RE: Planning Application for Proposed Wind Farm Development SSE Crumhach Wind Farm, Co. Sligo. An Coimisiún Pleanála - Case reference: PAX21.324561. Expression of concerns/issues arising - Mary T Finnegan concerning lands at Leharrow, Dromore West Co Sligo. Folio - SL 10702 refers.

Appendix 1 – Map a

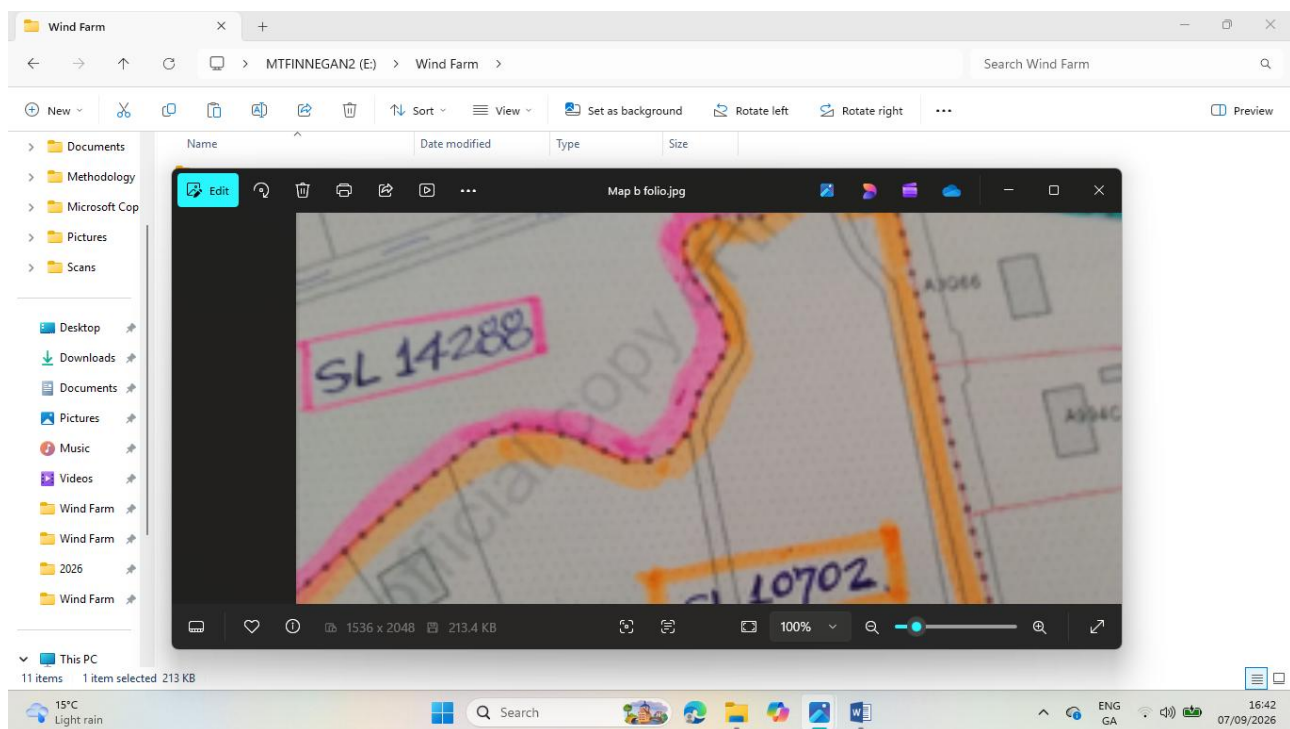
It has come to my attention in recent weeks that the proposed upgrading of the extant wind farms at Duneil and Kingsmountain to a 102 MW farm called Crumhach Wind Farm under Section 37E of the Planning and Development Act 2000, as amended, is likely to impact negatively on a small holding (folio number –SL10702) that I am the registered owner of at Leharrow, Dromore West, Co Sligo. Map a – Appendix 1 refers.

Appendix 1 – map b

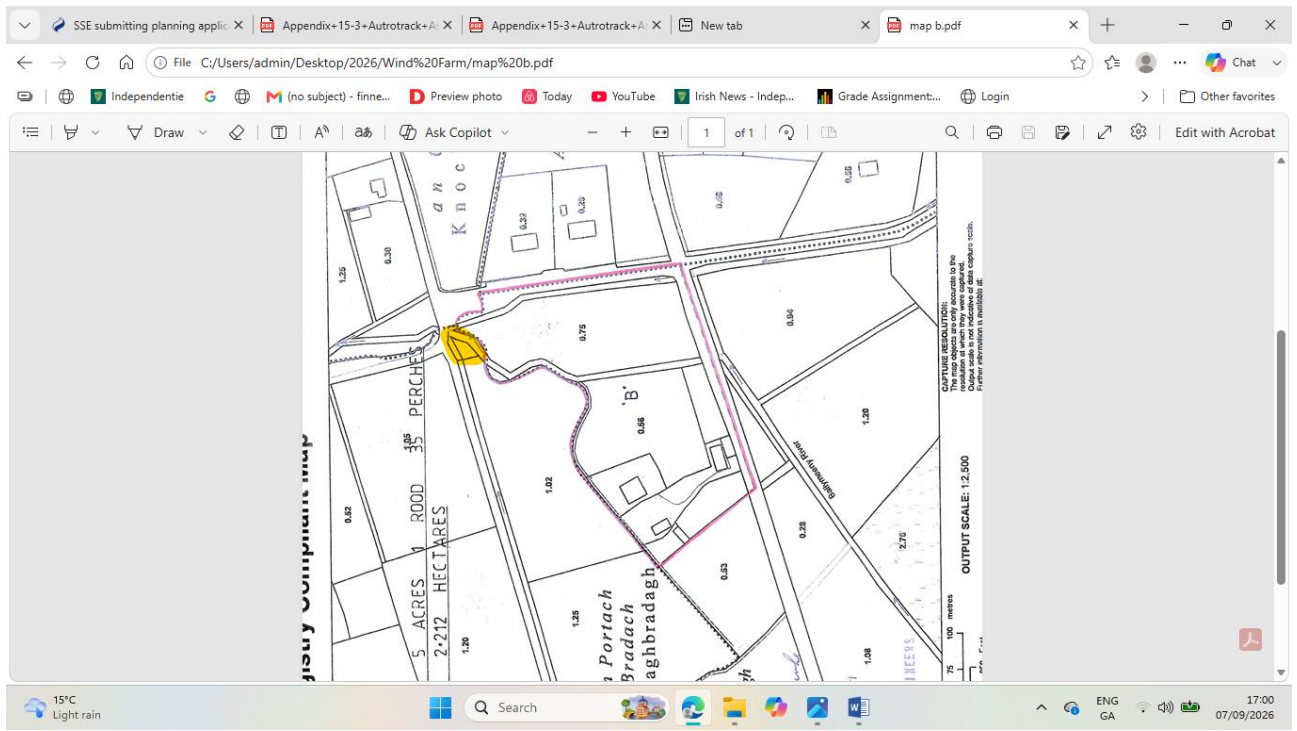
Crucially, the lands are adjacent to the 90 degree narrow bend on L63072 at Lehaarrow, Dromore West. Map b – Appendix 1 outlines. This is referred to as Location 17 in the submission document Map c – Appendix 1 refers. My concerns and the issues, I request to be addressed forthwith are as follows:-
